## SERVICE BULLETIN

**APPLICABILITY:** 2022-25MY Outback Wilderness

**NUMBER:** 07-237-25

**SUBJECT:** Blind Spot Detection Radar  
Assembly / Design Change

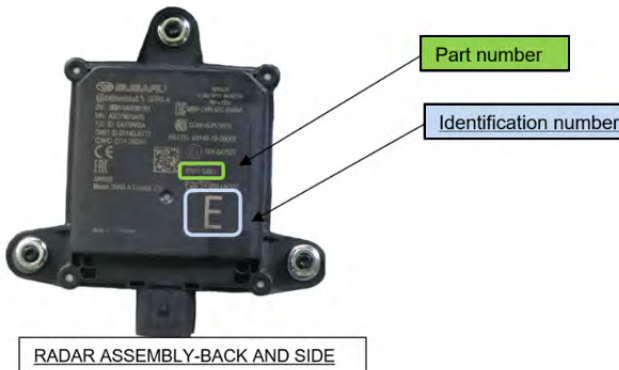
**Visually inspect** the part number printed directly on the radar unit. The part number is located next to the identification number.

**Note:** Ensure both rear radar assemblies have part number **87693-AN00A** or a newer superseding version. Replace any radar unit if the part number is **87611XC02A** or older.
